## FREDERICK COUNTY PLANNING COMMISSION August 11, 2010

TITLE: POINT OF ROCKS COMMUNITY COMMONS PARK PRELIMINARY MASTER PLAN

**REQUEST:** Present an overview of the Point of Rocks Community Commons Park Preliminary Master Plan for Planning

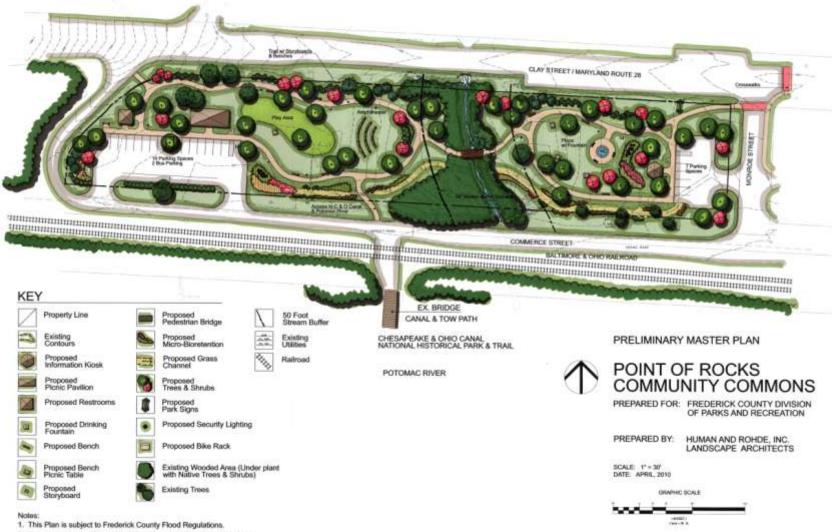
The grass channel edges are to be planted with shrubs & grasses to provide a deterrent to accessing the rail lines.

- The entire park is within a flood plain. Activities within the Federal Emergency Management Agency (FEMA) floodplain are subject to regulations of the State of Maryland, Frederick County Flood Regulations and the FEMA and may require permits from MDE and/or the Corps of Engineers.

- No new development including parking lots and walking paths impervious to water, or fill or excavation operations in conjunction with development will be permitted

- CSX has concerns about safety along the railroad and wants a deterrent to prevent/discourage park users from going onto the train tracks. Per the Plan the grass channel edges are to be planted with shrubs and grasses to provide a vegetative buffer to the train tracks.

- The Committee would like the County & State Highway Administration to pursue constructing a sidewalk along the north side of Clay Street (MD 28).
- The feature in the Plaza area whether a fountain or sculpture should be based on the theme that the site floods.

- The play area should be a natural playground utilizing materials native to the area and reflecting the historical character of the site.
- The existing wooded area within the 50 foot stream buffer is to be selectively cleared of invasive species and under planted with native trees and shrubs.
   Birdhouses should be incorporated into the area.

- A storyboard should be located prior to crossing Commerce Street to alert pedestrians of the railroad crossing and safety concerns.
- A "Canal Town" storyboard could be placed on the spur trail that connects to the C & O Canal listing the facilities in Point of Rocks and direction to the kiosk for hikers and bikers traveling the Canal tow path.

- The security lighting in the park should be pedestrian level lighting only (poles from 10 to14 feet high). The lights should be on a timer so that they can be turned off at 11:00 PM.
